Location of Construction: 739-741 Warren AVe	Owner: Warren Ave	Corp	Phone: 934-7505	Permit No:
Owner Address: P.O. Box 262 00B 04064	Lessee/Buyer's Name:	Phone:	BusinessName:	
Contractor Name: Bailey sign Inc.	Address: 9 Thomas Dr Westbr	Permit Issued:		
Past Use:	Proposed Use:	COST OF WOI	RK: PERMIT FEE: \$ 33.00	
KXMMXXXXX Office Building	Same	FIRE DEPT.	Approved Denied INSPECTION: Use Group: Type:	Zone: CBL: 316-A-005
Proposed Project Description:		Signature: PEDESTRIAN	Signature: ACTIVITIES DISTRICT (P.A.D.)	Zoning Approva
40 sq. ft Sign (remove existing free stan new tenant directory)	Action: Signature:	Approved Approved with Conditions: Denied  Date:	Special Zone or Reviews:  Shoreland Wetland Flood Zone Subdivision	
Permit Taken By: SP	Date Applied For:	July 23, 1998		☐ Site Plan maj ☐minor ☐min
<ol> <li>This permit application does not preclud</li> <li>Building permits do not include plumbin</li> <li>Building permits are void if work is not stion may invalidate a building permit ar</li> </ol>	ng, septic or electrical work. started within six (6) months of the date of			□ Variance □ Miscellaneous □ Conditional Use □ Interpretation □ Approved □ Denied  Historic Preservation □

## (1) D.F. 8'-0" X 5'-0" X

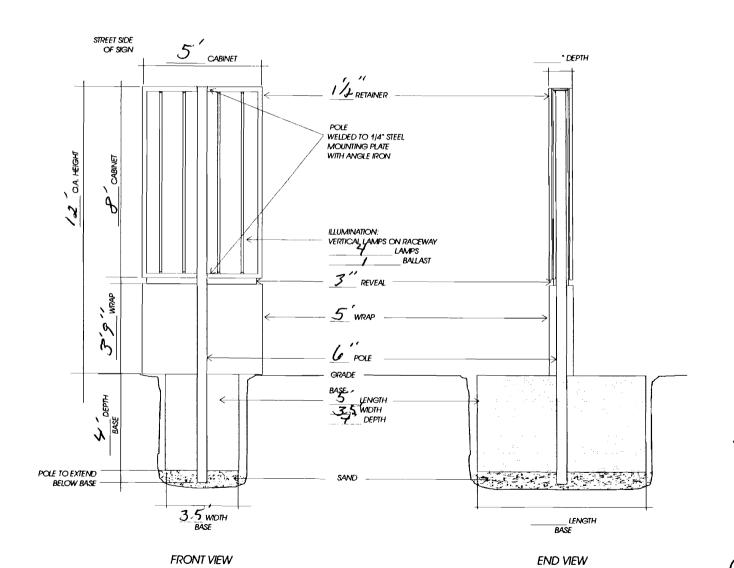
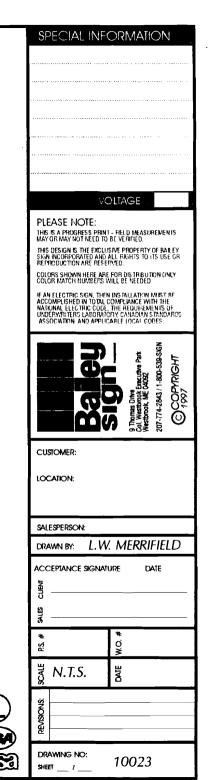
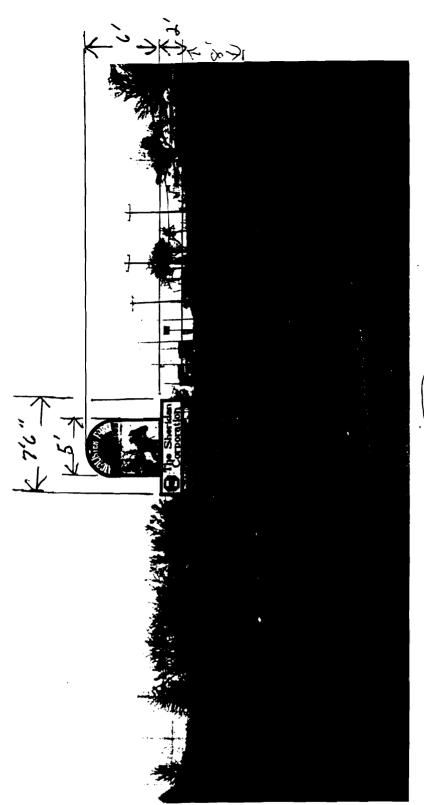
7.	Separate permits shall be required for any signage.
9.)	Separate permits shall be required for future decks and/or garage.  Other requirements of condition This Sign Shall be No Kher
	Than 15 feet instead of The 16' ? 12' haigh
	Shown on your stars -
	Marge Schmuckal, Zoning Administrator,
	Asst. Chief of Code Enforcement
